GROUP <b>ELE</b>	MODEL <b>2012~2013MY Rio (UB)</b>
	NUMBER <b>067</b>	DATE <b>October 2014</b>
<b>TECHNICAL SERVICE BULLETIN</b>		
SUBJECT: <b>IN PANEL MODULE (IPM) REPLACEMENT – DTC C1611</b>

**SUBJECT: IN PANEL MODULE (IPM) REPLACEMENT – DTC C1611**

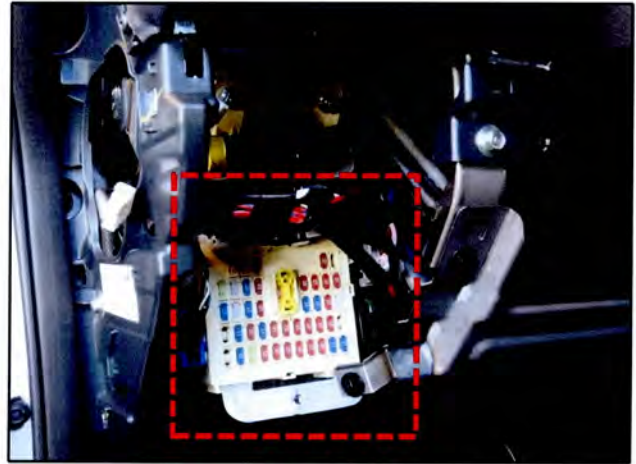
This bulletin provides the procedure to replace the In-Panel Module (IPM) of some Rio (UB) vehicles produced from November 7, 2011 through October 30, 2012, which may experience a momentary decrease in power steering assist, at times accompanied by a flashing ESC lamp and DTC C1611(MDPS CAN communication Error to ECU). This condition typically will occur more often during start up/at idle, and in areas with low ambient temperatures, when intermittently poor contacts in specific IPM circuits may result in CAN communication errors. When this happens, DTC C1611 may be set and the power steering assist level will decrease. Although cycling the key will restore the power steering assist to the normal level, customers may complain of sometimes having to use a higher than normal amount of effort to steer the vehicle. To resolve the concern, replace the In-Panel Module (IPM) with an improved part by following the applicable service procedure on KGIS and by utilizing the information in this bulletin.

1. Refer to KGIS for the In Panel Module (IPM) (A) removal and reinstallation procedure, as shown below.

2. Clear any DTCs in all control modules and confirm proper vehicle operation after installation is complete.
